SANTA MONICA MOUNTAINS CONSERVANCY

Agenda Item 10
SMMC
4/25/11

**Pepperdine University Campus Life Project
Final Environmental Impact Report
SCH# 2008041123**

Public Trails / Easements

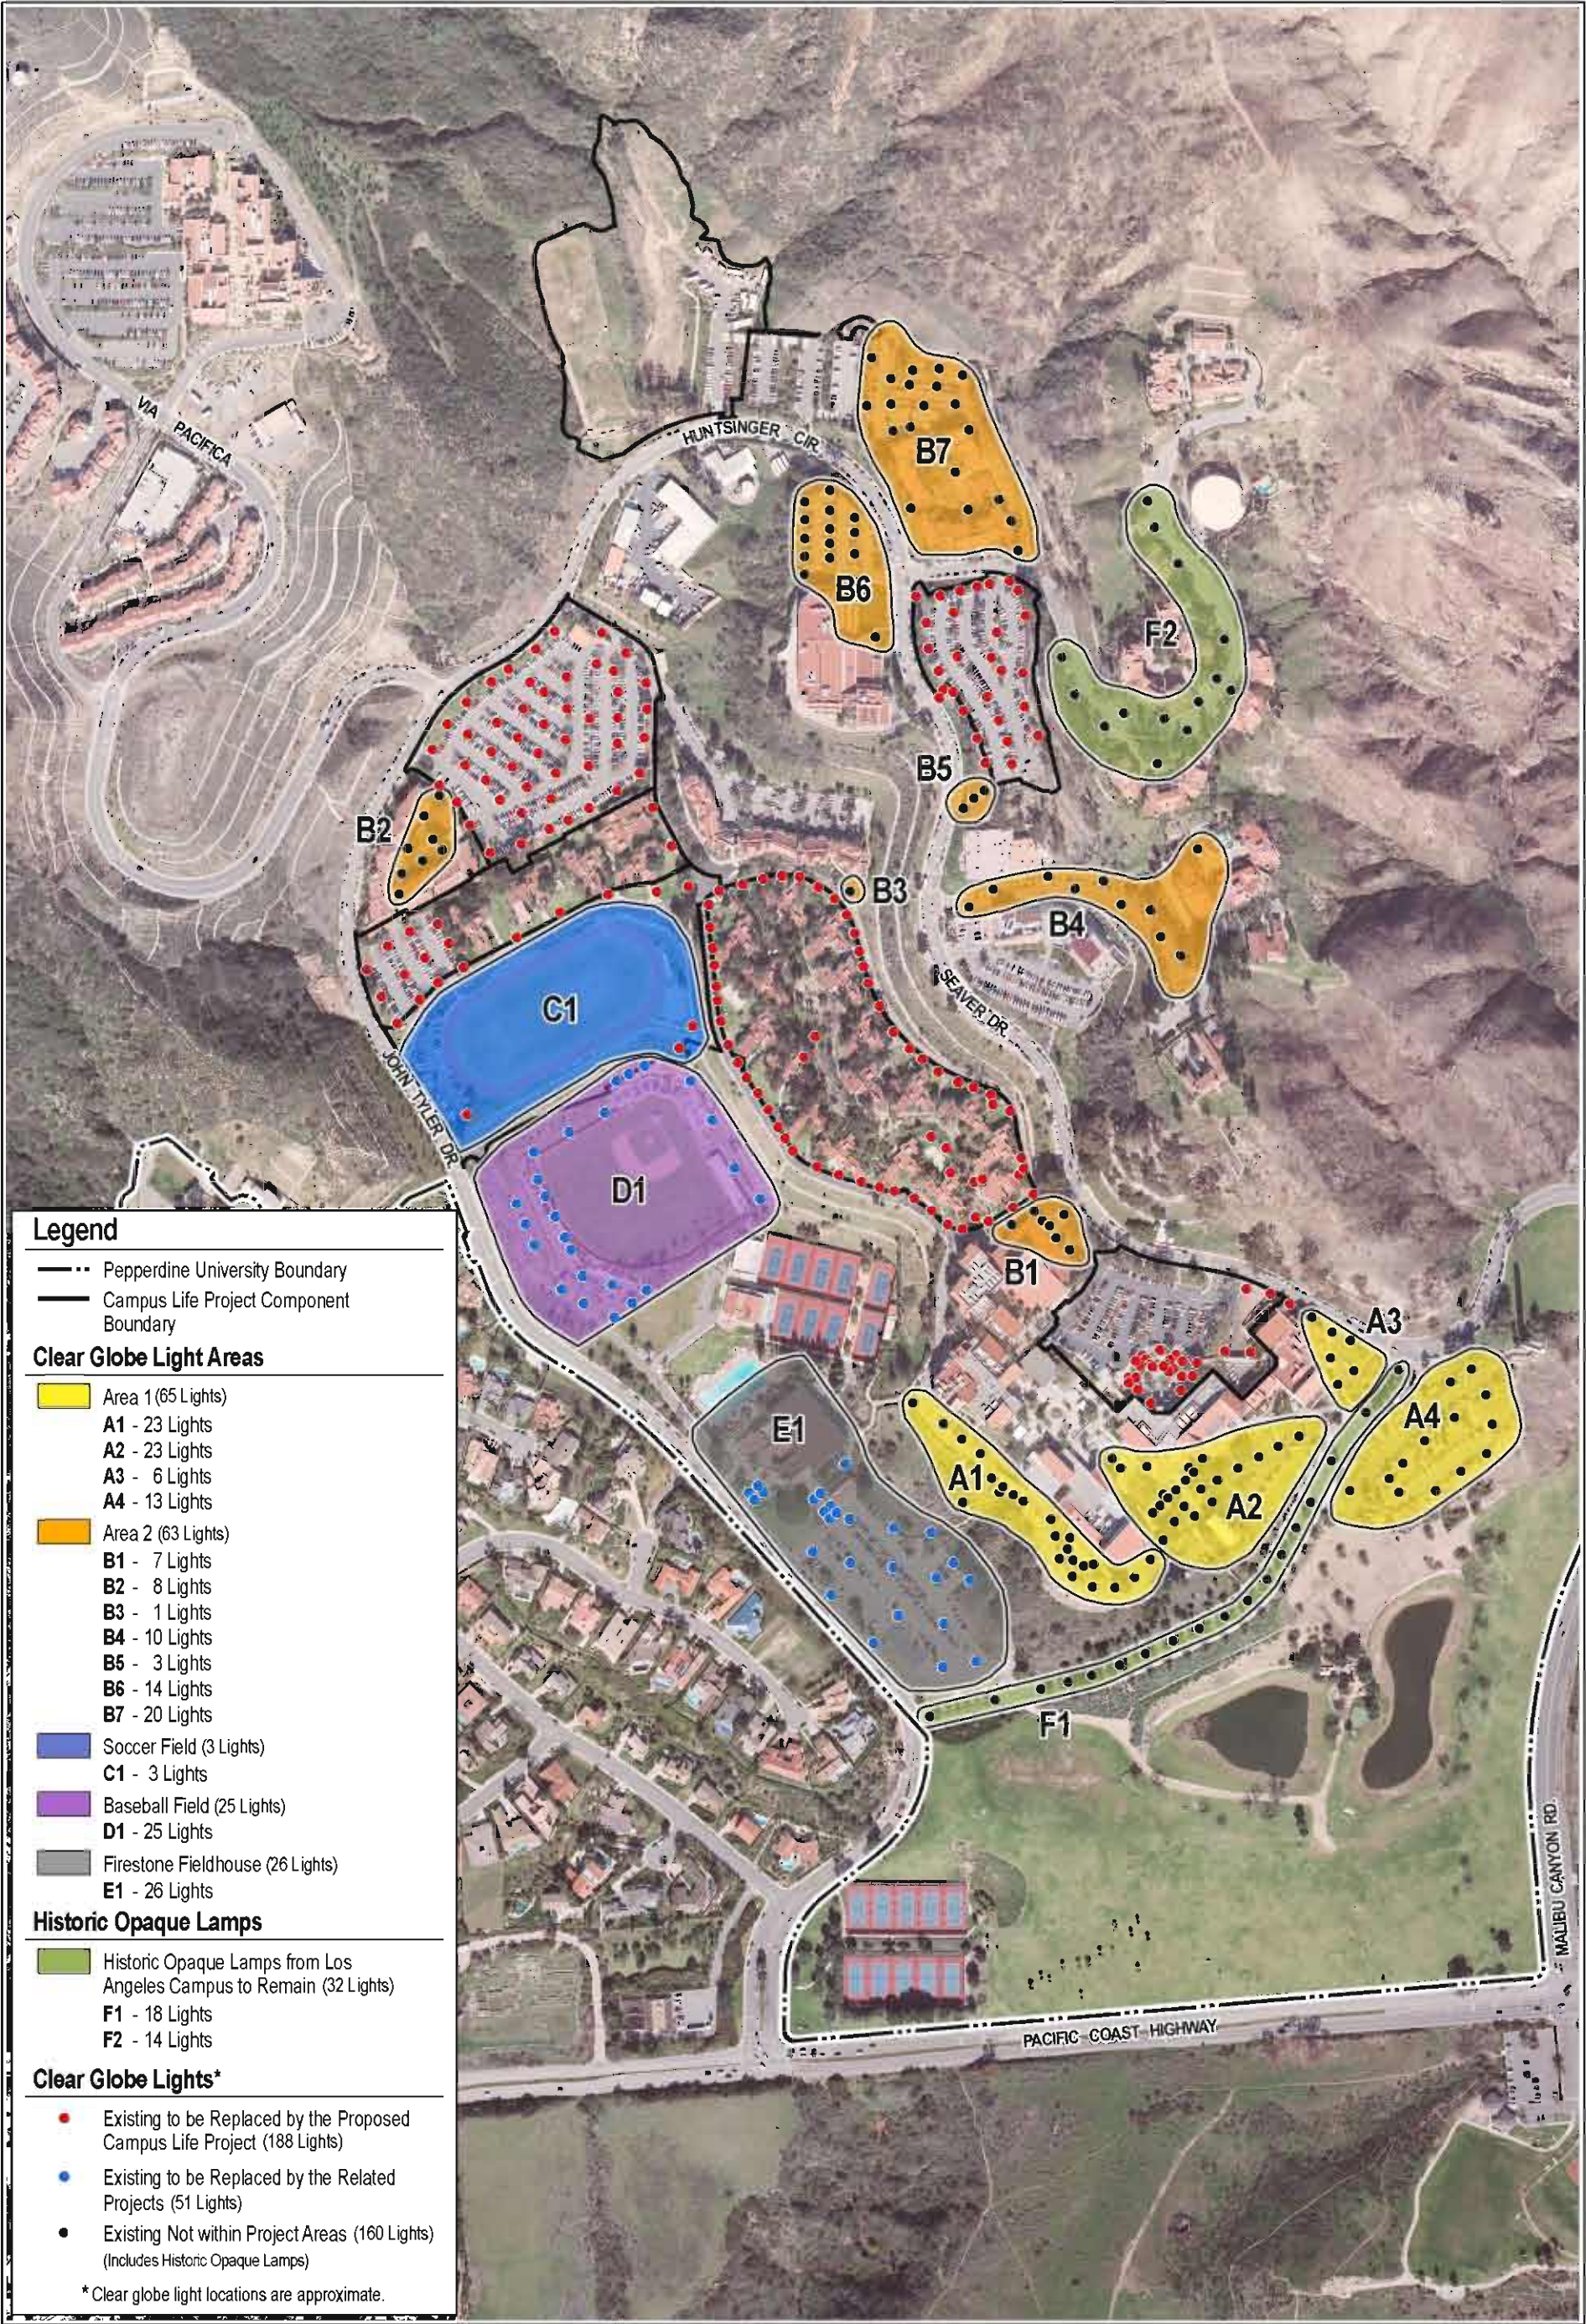
Proposed Measure No. 6: Pepperdine shall offer to dedicate an easement of new realigned trails, consistent with one of the alignments ("Other Potential Easements") shown on the attached figure entitled "Public Trails/Easements," if determined appropriate in the future by the Conservancy to be more viable than the existing offer to dedicate. Prior to the issuance of the building permit for the first component of the CLP, Pepperdine will provide a binding legal assurance that at some point in the future, if the Conservancy requests a new alignment (consistent with the alignments shown on the attached figure), then Pepperdine will record such offer or will directly grant a trail easement. Such new realigned trail easement shall be 50 feet in width for planning, and shall allow 20 feet in width for construction. The "Current Proposed Mesa Peak Trail" (green line on the Pepperdine property as shown on the attached figure) would continue to remain as part of any final trail easement. If the existing offer to dedicate is set to expire prior to resolution of any guaranteed trail connections on adjacent properties, Pepperdine will extend the existing offer to dedicate for 21 years.
